Interactive comment on “Towards a stable and absolute atmospheric carbon dioxide instrument using spectroscopic null method” by B. Xiang et al.

B. Xiang et al.

Received and published: 22 May 2013

Fig. 1. Potential spectral region for cocurrent water measurement

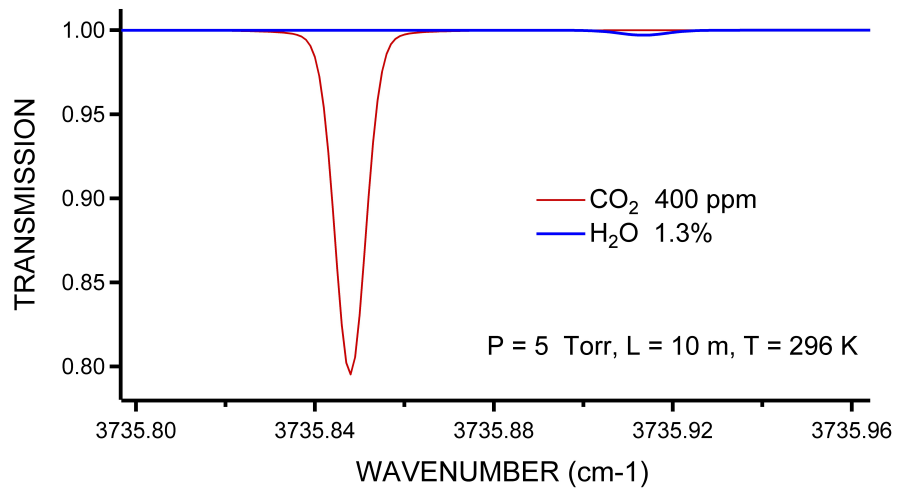
[RC] General remark: As pointed out in the conclusions, the major disadvantage of the instrument is the lack of concurrent measurement of H₂O. This would be a requirement for successful application in the field, since other techniques (e.g. CRDS) with proven reliability of the water vapor corrections are already commercially available (e.g. Rella et al, 2012).

[AC] Agreed. The manuscript already states that this is a disadvantage and that we have plans to address it by measuring water vapor. See below for one potential spectral region.
